Integrated Device Technology, Inc.
2975 Stender Way, Santa Clara, CA - 95054

PRODUCT/PROCESS CHANGE NOTICE (PCN)

PCN #: SR-0210-03 DATE: 27 Oct 2002 Product Affected: TSOP (PH44) product in Trays Date Effective: 27 Jan 2003	MEANS OF DISTINGUISHING CHANGED DEVICES: <input type="checkbox"/> Product Mark <input type="checkbox"/> Back Mark <input type="checkbox"/> Date Code Tray manufacturer changed <input checked="" type="checkbox"/> Other From " Kostat " To " Daewon "
---	---

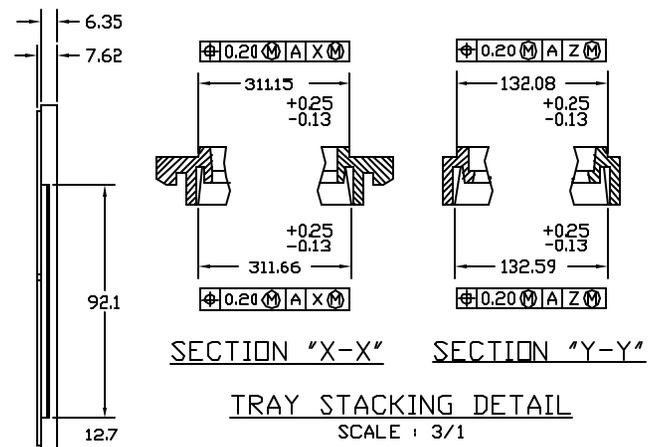
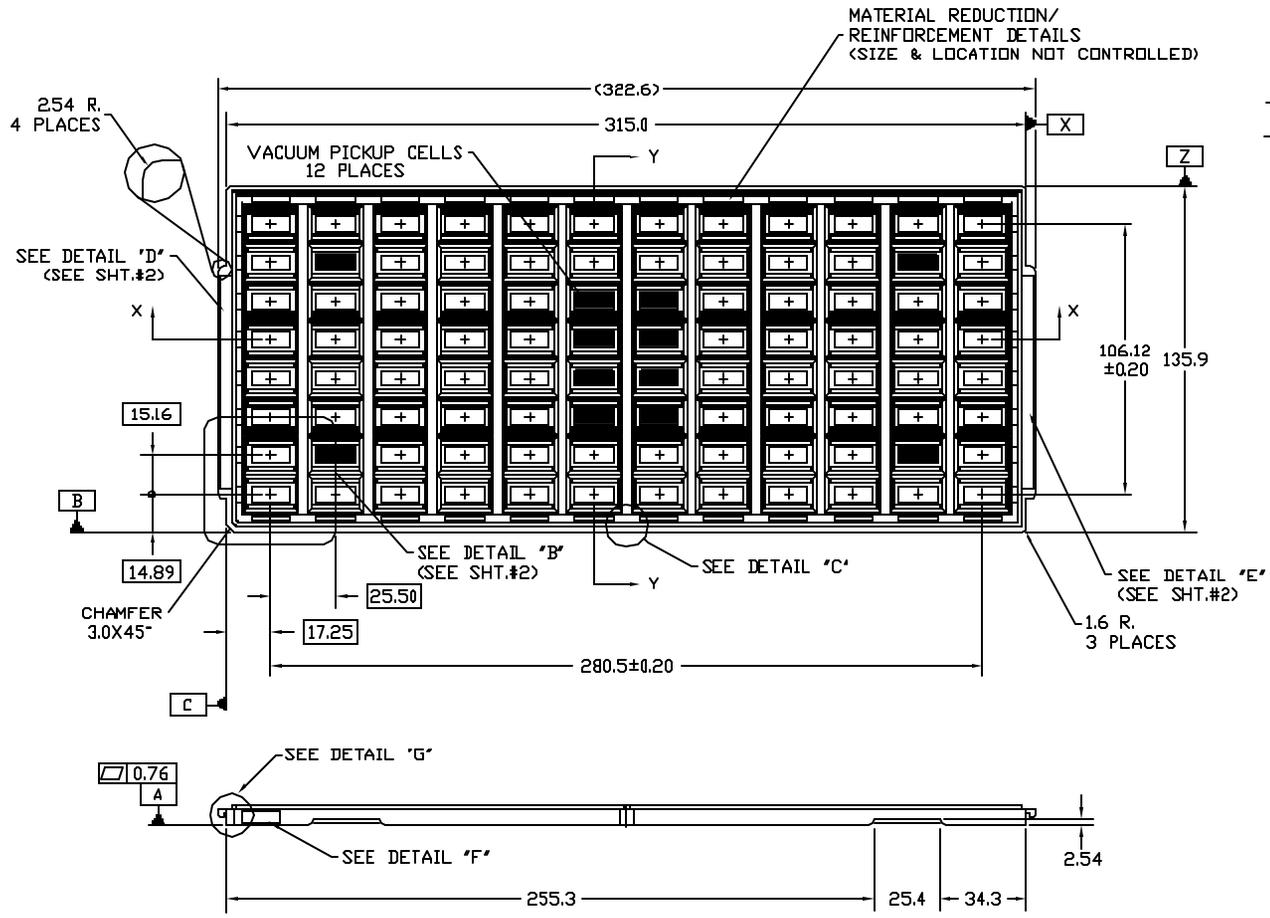
<input type="checkbox"/> Die Technology <input type="checkbox"/> Wafer Fabrication Process <input type="checkbox"/> Assembly Process <input type="checkbox"/> Equipment <input type="checkbox"/> Material <input type="checkbox"/> Testing <input type="checkbox"/> Manufacturing Site <input type="checkbox"/> Data Sheet <input checked="" type="checkbox"/> Other - Shipping Tray	To change the shipping quantity for TSOP (PH44) product in trays. Trays are compliant to JEDEC 95 standards. Tray size (outside dimensions) will remain same.
--	---

Description	Current Tray	New Tray
Drawing Number	MSC-1448	MSC-1738
Quantity per Tray	135	96
Pocket Size	13.67mm x 20.42mm	15.16 x 25.50mm
Tray Matrix (Qty.)	9x15	8x12
